DESIGN RECOMMENDATION MEETING

9201 Delridge Way SW
Seattle, WA 98106

3029353, 3029353-EG

2/21/19

PROPOSED DESIGN

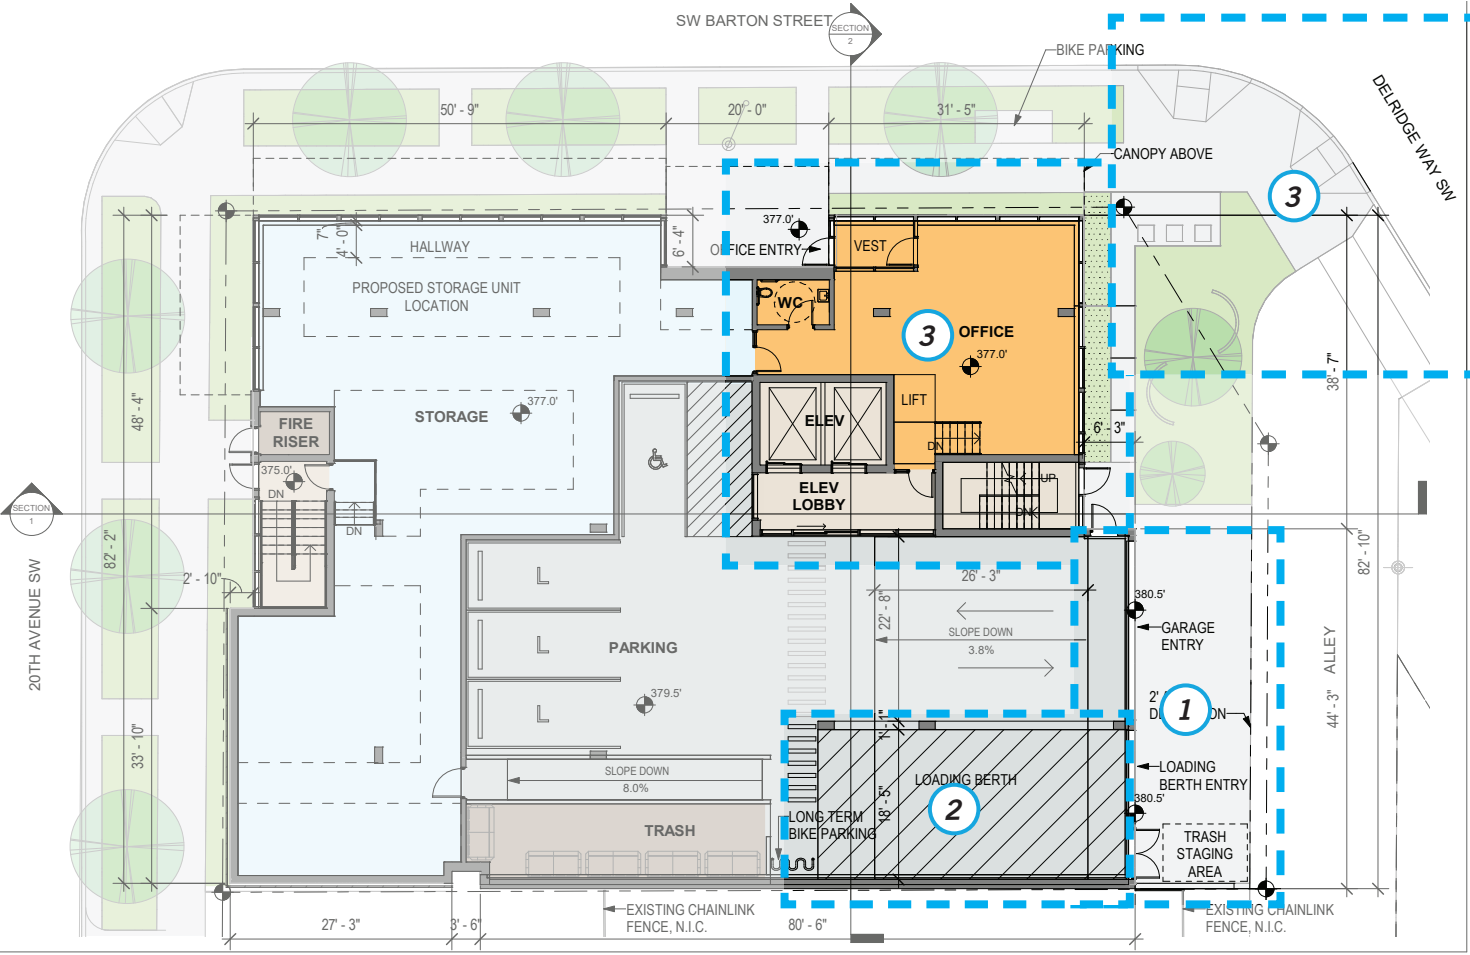
The Board acknowledged public comment highlighting the residential character of the neighborhood while emphasizing the importance of an active street front with adequate room for pedestrian traffic to pass and avoid conflict with vehicles. In summary, the Board supported elements of the Option 2 and 3 ground floor programs, as described below. Develop the ground floor program to respond to the goals of activating the street and reducing pedestrian-vehicle conflicts at the alley.

A. Option 1 (EDG Packet, pages 15-25): The ground floor plan proposed office space at the northwest corner, stretching along 20th Ave SW and SW Barton St. A vestibule at the northeast corner offered pedestrian in/egress out onto the alley. Immediately to the south of this vestibule was a surface loading zone and vehicular entrance to the garage. The Board agreed that reducing pedestrian-vehicle conflicts is an important consideration, particularly at the alley, and for this reason, the Option 1 ground floor was the least preferred option.

B. Option 2 (EDG Packet, pages 26-33): The ground floor of Option 2 also focused the office at the northwest corner of the ground floor. However, with a nearly 1,000-square foot reduction in size, the office did not extend as generously along SW Barton St as Option 1. The vehicle loading space was moved into the parking garage, and the vestibule was moved to 20th Ave SW. The entrance to the parking garage was located at the furthest south portion of the site, off the alley. The Board supported the location of loading zone within the parking garage with entrance to the garage at the south end of the site off the alley and recommended maintaining the garage entry location as shown.

C. Option 3 (EDG Packet, pages 34-40): The ground floor proposed office space at both the northwest and northeast corners with vestibule in between. The loading zone was located again within the parking garage, with entrance to the garage further north in the alley, close to the entrance for the northeast corner office. The Board supported the location of uses along 20th Ave SW and SW Barton St, while expressing concern that the location of the loading zone and entrance to the parking garage required the most amount of vehicle maneuvering in proximity to pedestrian circulation at the northeast corner.

- 1
- As recommended by the Board, the loading zone and garage access have been located furthest south of the building to reduce pedestrian-vehicle conflicts.

- 2
- As recommended by the Board, the loading zone was brought inside the building to enhance the building’s presence from the corner and to reduce pedestrian conflicts.

- 3
- The proposed office space was located on the northeast corner of Delridge Way SW and SW Barton Street for greater visibility. Further study was given to truck maneuverability into the building to make loading and unloading faster and safer.

VIEW OF NORTHEAST CORNER FROM DELRIDGE WAY SW

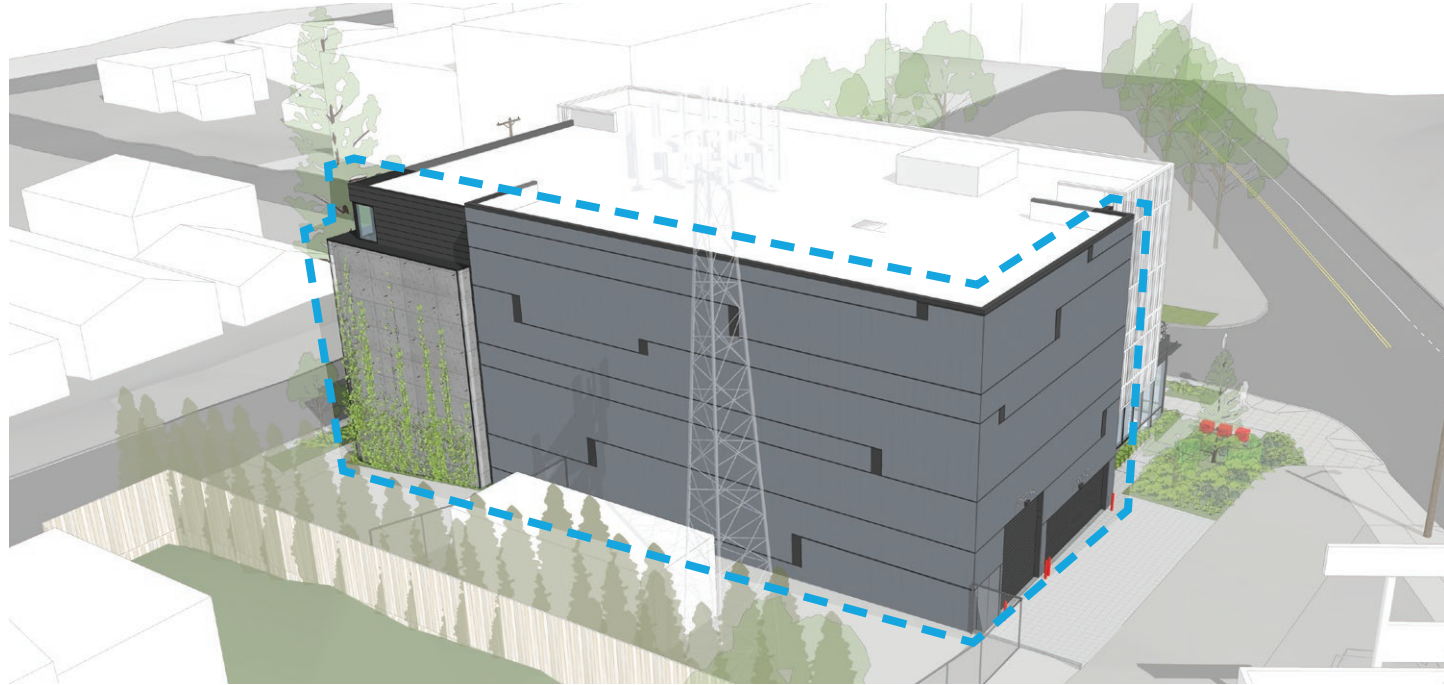
A. The architectural concept was described as the creation of two uniform boxes, one stacked on top of the other, expressing the interior use in the exterior design (storage and service/office). The ground level is to be open and articulated with fine grain details and landscaping, while the upper level houses the storage units and would be more uniform expression. Texture and material are intended to add interest to the building (page 13, EDG Packet). The Board supported this architectural concept, agreeing that the project could be a beautiful sculptural object with simple massing and materiality to address scale. The Board agreed that Option 2 was the most successful at articulating this architectural concept with its simple and consistent forms.

As supported by the Board, Option 2 and its visual presence was further developed. Care was taken to ensure that the supported massing concept was not compromised in its design development. Due to the building’s blank facades and lack of windows, materiality plays a strong part in the success of the concept. Different materials were applied to the “boxes” to help break down the scale of the facade while maintaining a clean, “stacked box” concept.

The proposed material along the south facade and on Delridge Way SW will be high quality fiber cement paneling with custom patterning to create a unique architectural presence while maintaining a clean aesthetic. Materials along the SW Barton Street will be highly modulated metal paneling and glazing while 20th Avenue SW will have more metal paneling, glazing, and concrete with a green screen. Collectively, the building will present different palettes of materials and color from differing vantage points.

NORTHEAST CORNER

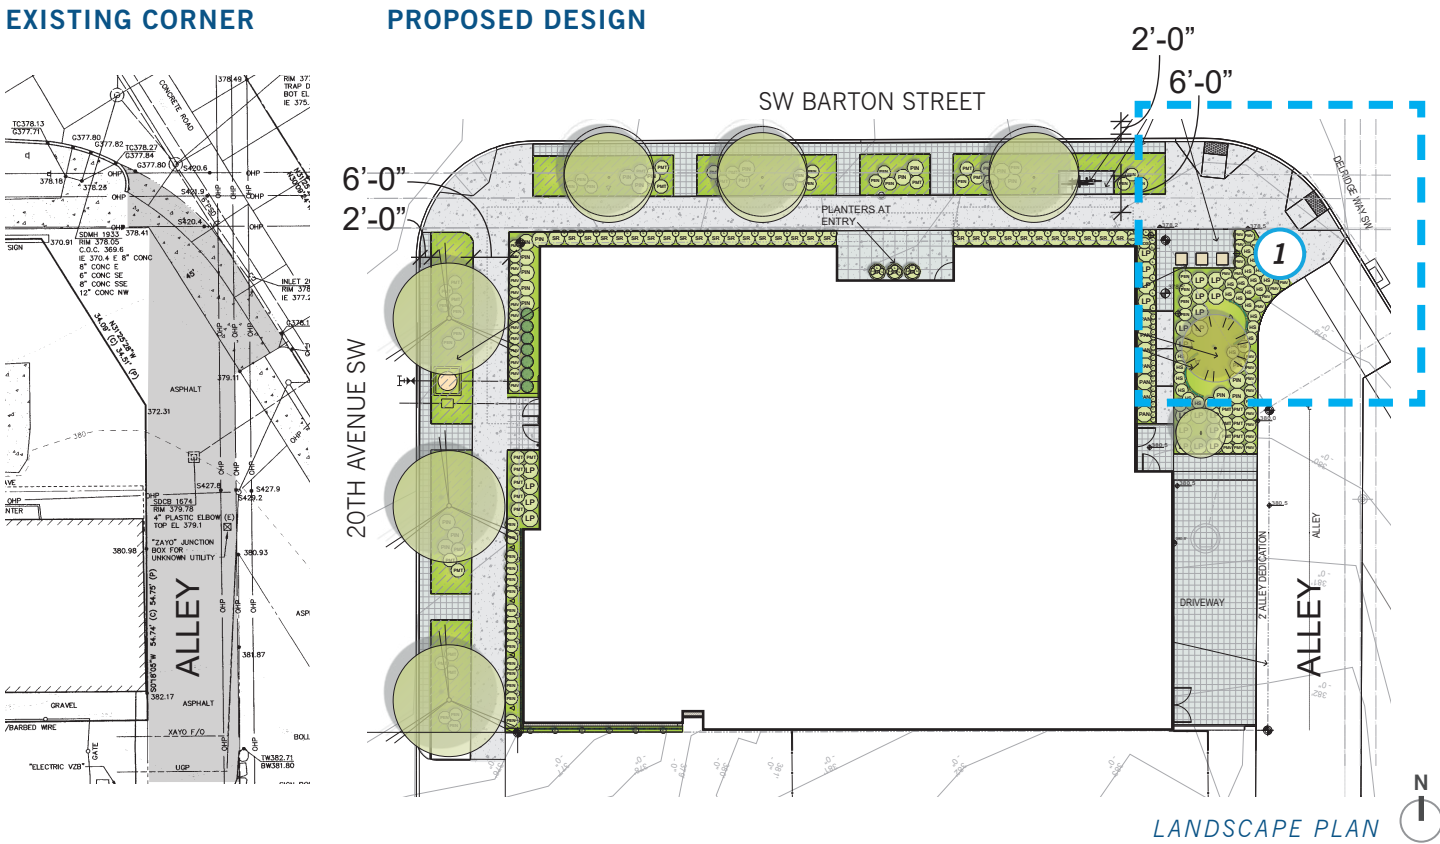
4. In further support of the future pocket park to the east and public request for safe pedestrian circulation, the Board recommended the SW Barton Street sidewalk be as wide as possible. The proposed ground level greenspace along SW Barton Street was supported in further pursuit of these objectives.

The sidewalk along SW Barton Street and 20th Avenue SW will be widened from 5' to 6' to accommodate smoother pedestrian flow while maintaining large landscaping strips on either side. 2' pavement strips are also proposed along the curb of both streets to accommodate easy mid-block access for on-street parking. A 6' sidewalk was chosen over a wider design in support of more generous landscaping along both street fronts and between the sidewalk and proposed building facade. This will increase perceived protection from the street and make for a more enjoyable pedestrian experience. Additionally, both streets are also largely residential in character and 6' is believed to be generous enough to handle pedestrian traffic now and into the future.

With the support of SDOT, improvements to the corner of Delridge Way SW and SW Barton Street are also proposed. Improvements include angling the alley entrance off of the corner, reducing the alley entrance width to 20', extending the corner and additional 3'-6" into the street, adding an additional curb ramp to connect to the future pocket park. These improvements will allow for a safer corner with more space for pedestrians and fewer areas of conflict between pedestrians and motorists.

VIEW OF WEST FACADE

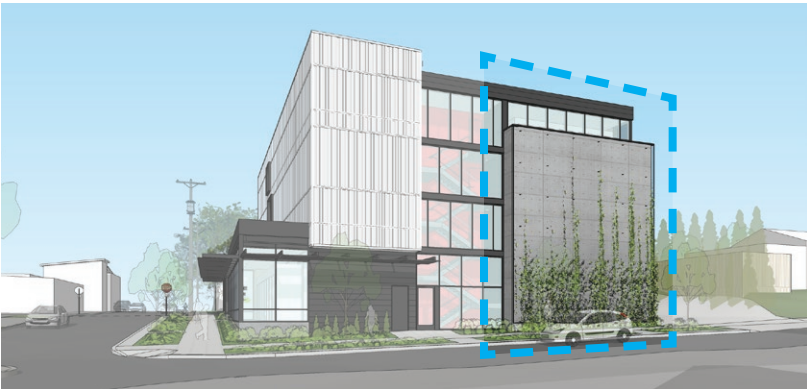
iii. Articulate Interior Uses on the Exterior. In addition to supporting the expression of the architectural concept in Option 2, the Board also supported how well Option 2 expressed its own residential use on the exterior. This residential use, a caretaker's unit, was proposed at the southwest corner of Option 2. The Board supported this location of the caretaker's unit because it overlooked 20th Avenue SW and beyond, to the low rise residential development to the west. To emphasize this residential use and response appropriately to the residential character of the neighborhood, the Board recommended this caretaker's unit be further expressed on the façade. The Board suggested an inset balcony in lieu of the four windows shown, as the inset balcony would be in keeping with the architectural concept. The four windows were described as unsuccessful in expressing the residential use.

While the caretaker unit was removed from the building's program, the Board's comments were taken into consideration in recessing the space above the proposed green wall. This helps to break down the scale of the facade, introduce more transparency into the space, and respects the residential character of the street.

VIEW OF SOUTHWEST FACADE

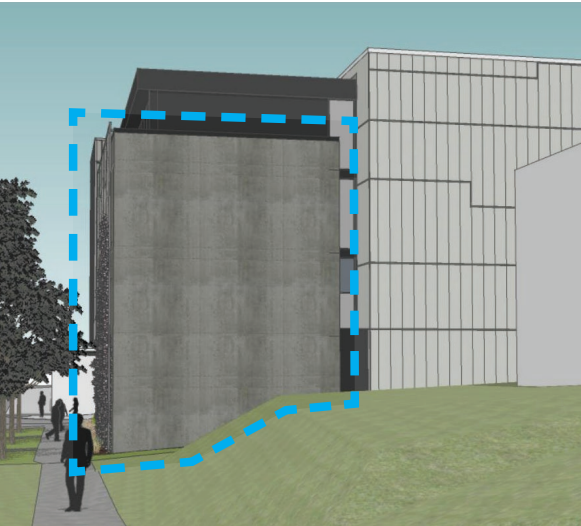
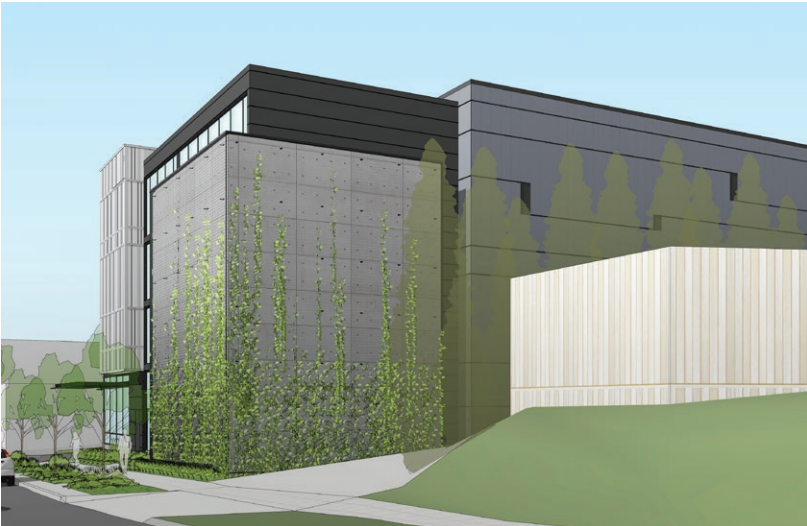
The Neighborhood attendees generally supported the proposed green wall on 20th Ave SW but suggested that the south facing facade will immediately get tagged with graffiti. The group discussed placing a mural on that wall, but tagging would still be an issue. Caron proposed returning the green wall screen partially along the south wall to discourage tagging, and this study was generally accepted.

In response to the neighborhood’s guidance, the proposed green wall has been extended to wrap around a portion of the south facade. It was determined that the green wall lattice that would support the ivy would provide enough of a deterrent to tagging. The recessed space was also shallowed to 1’-6” to deter encampment.

CORNER OF DELRIDGE WAY SW AND SW BARTON STREET

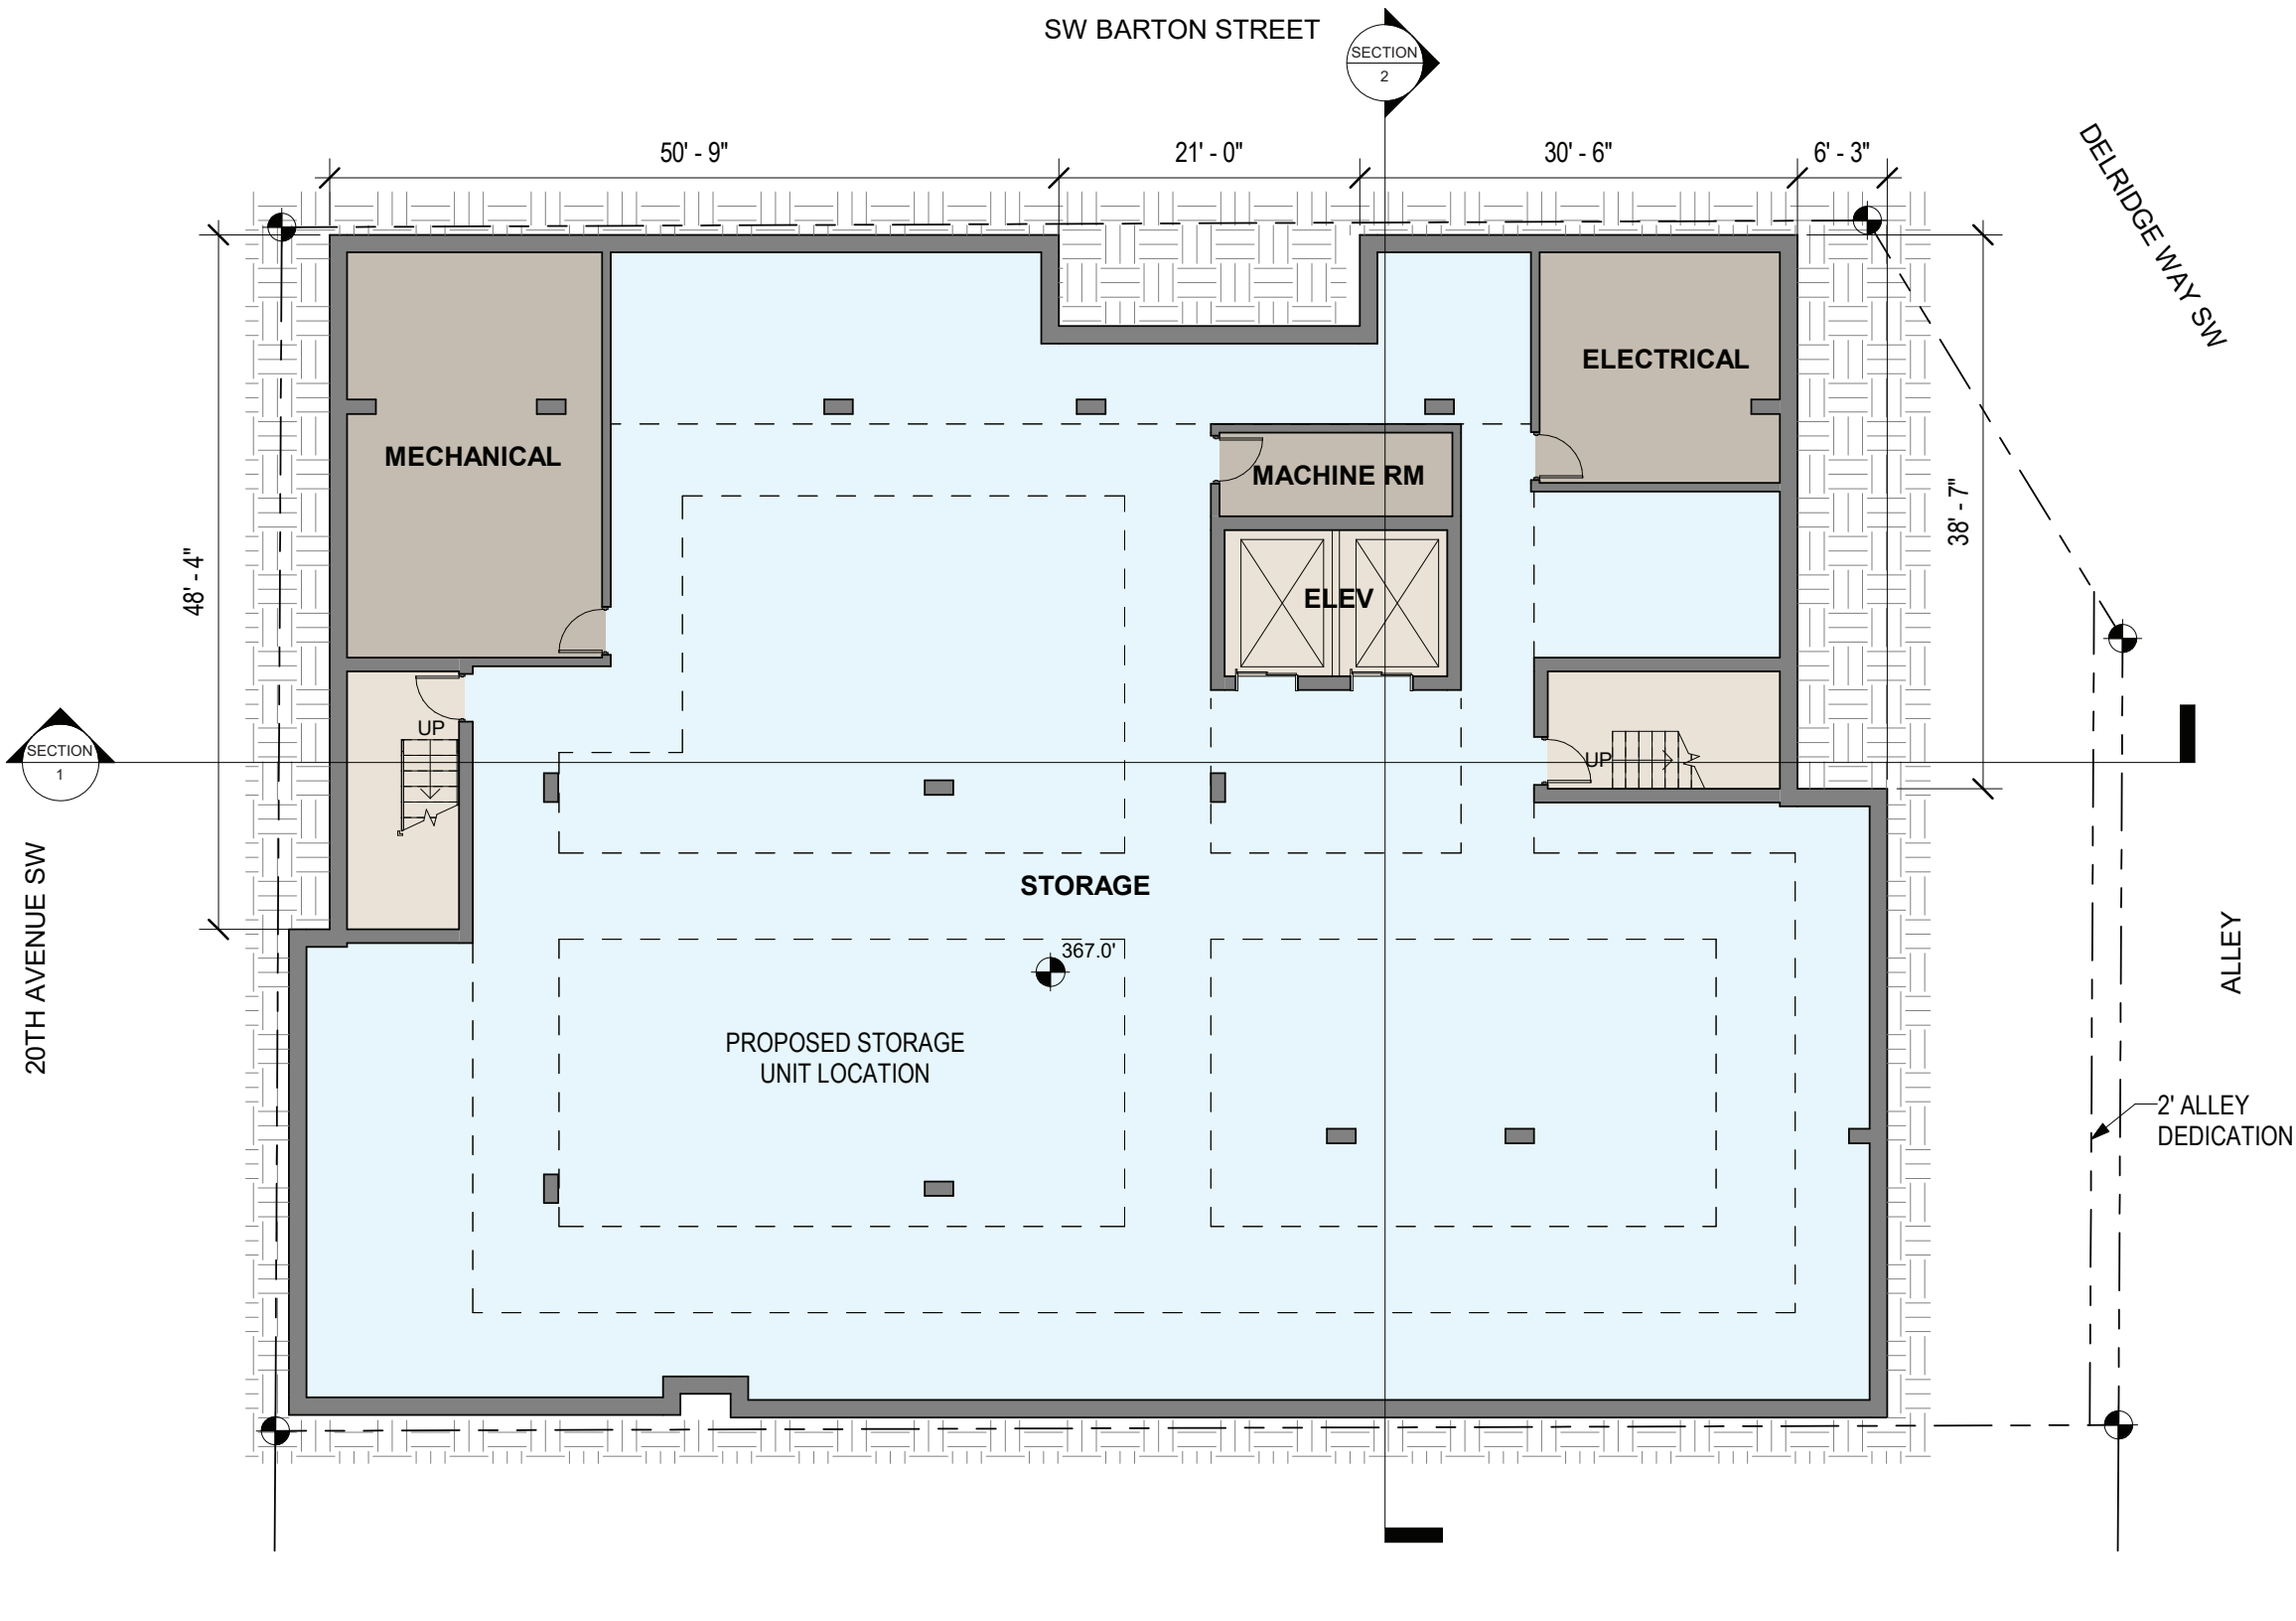
Neighborhood attendees were generally in support of the building setback facing Delridge and generous landscaping design on corner.

Landscaping on the corner of Delridge Way SW and SW Barton Street was retained and enhanced to promote a safe and convenient open space. Seating has been shifted farther from the corner to create a more pedestrian-friendly rest area. A low-sloping staircase was also introduced to connect the corner with the loading garage, creating better access without the need to walk along the alley.
